Tuesday, February 20, 2024

AGENDA

**VILLAGE OF
McFarland
SUMMARY SHEET**

AGENDA ITEM: Public Hearing on Resolution No. 2024-01, a Resolution approving Planned Development Infill District Detailed Plan for Jaeger Condominium located at 6303 Jaeger Road.

Plan Sheet C-1.1

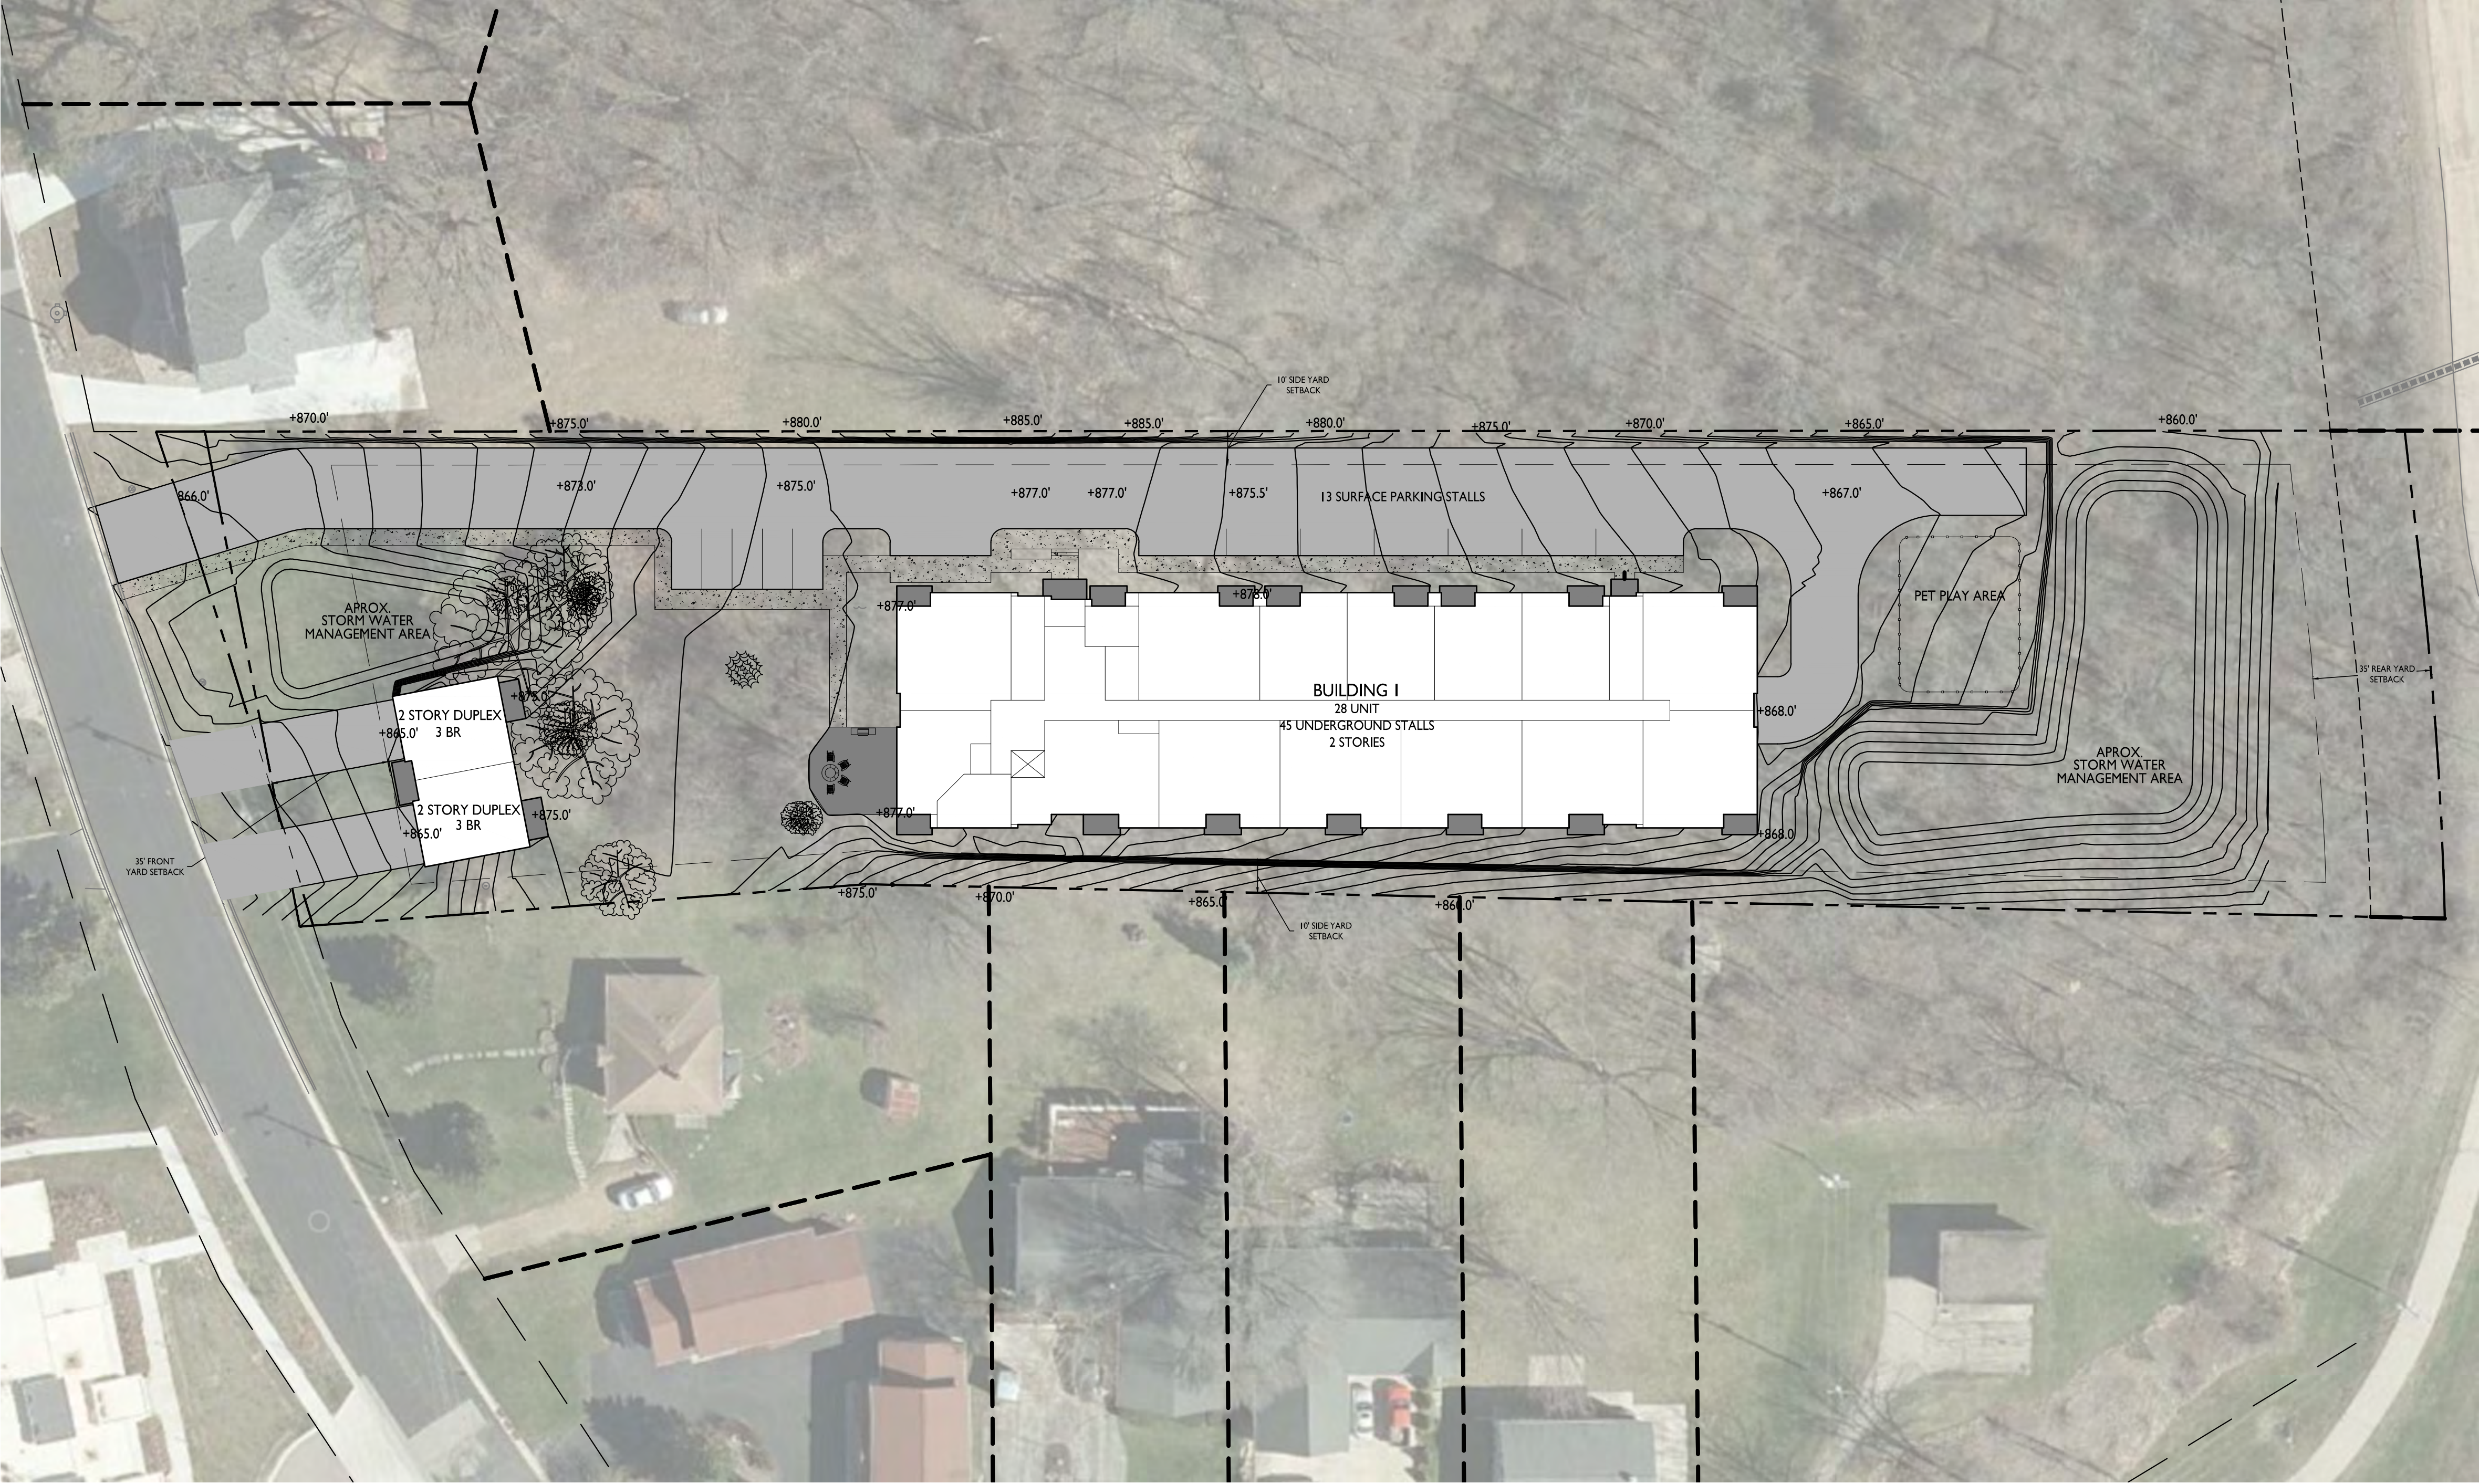
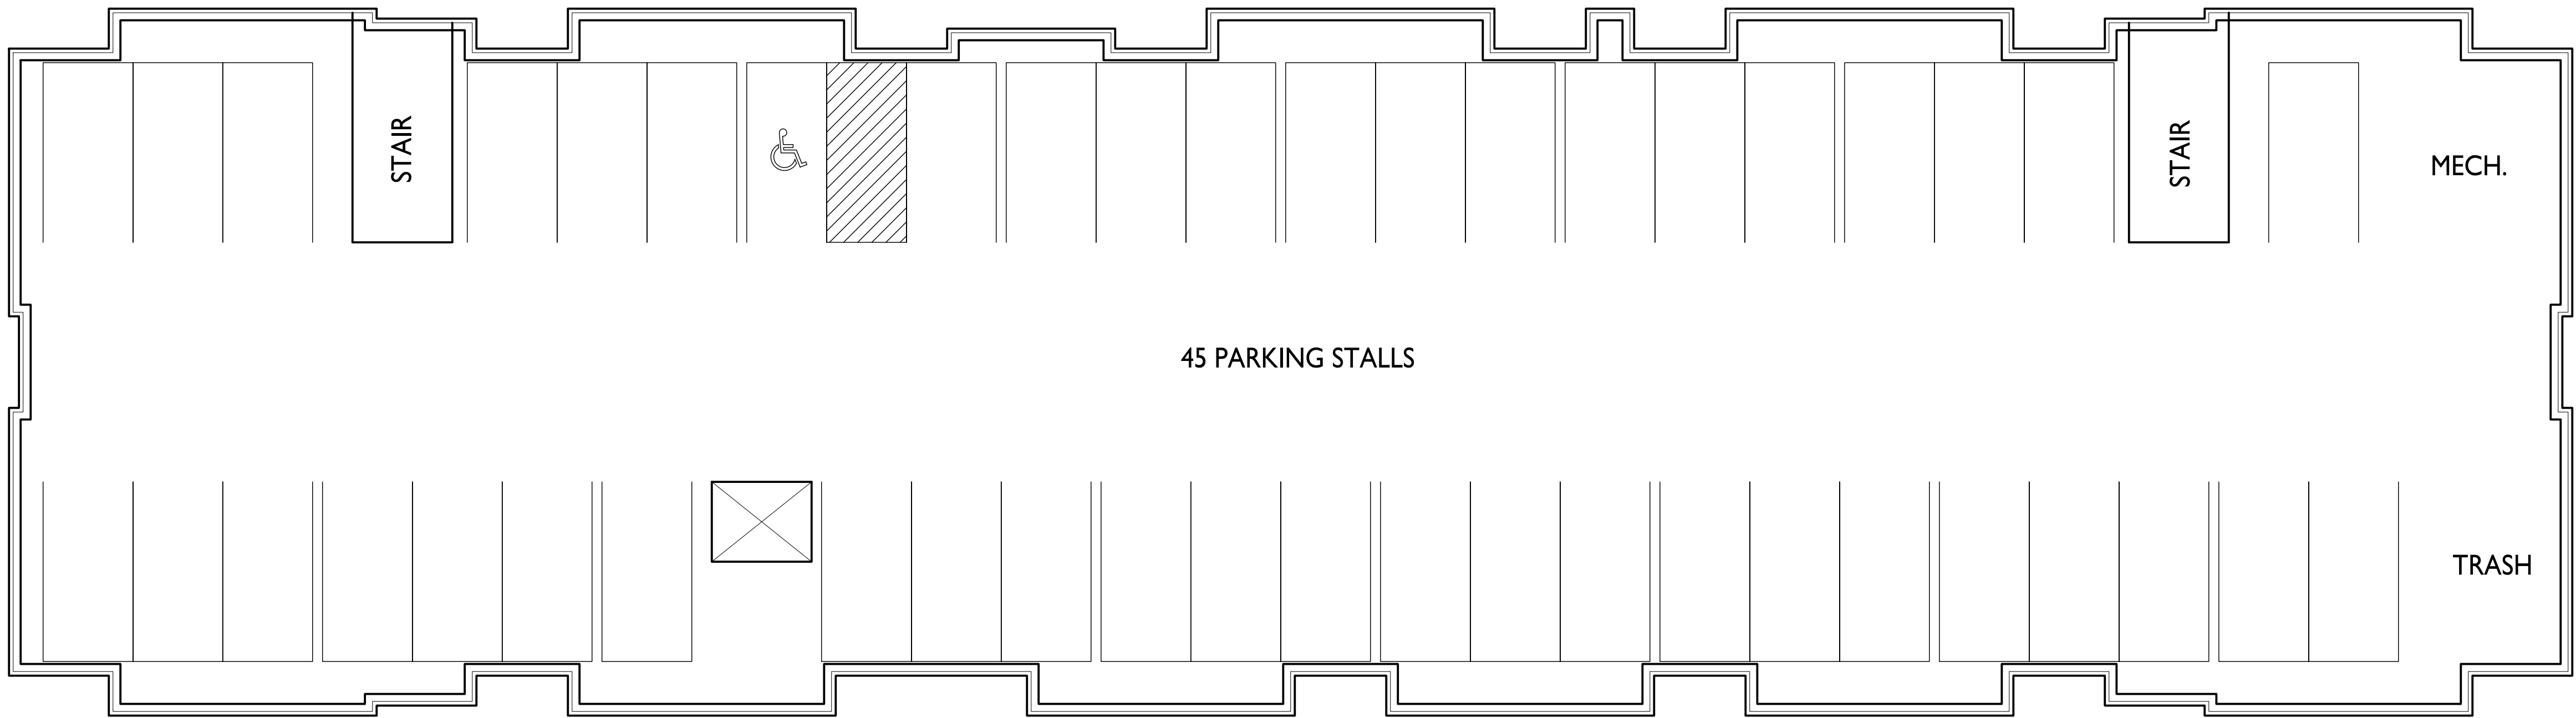
- IFC D103.1 (access road width a hydrant) increases the road width to 26 feet within 20' of a hydrant.
- IFC D103.4 Dead-end fire apparatus access roads in excess of 150 feet shall be provided with width and turnaround provisions in accordance with Table D103.4. Table D103.4 states access roads with a length of 501-750 feet will have a width of 26 feet.
- IFC D105 Aerial Fire Apparatus Access Roads
 - D105.1 Where required. Where the vertical distance between the grade plane and the highest roof surface exceeds 30 feet, approved aerial fire

We also noted IFC D103.1 indicates a minimum turning radius of 28' for the alternative hammerhead turnaround. The plans appear to indicate an alternative hammerhead turnaround on the east but appears the turning radius provided doesn't meet the requirement.
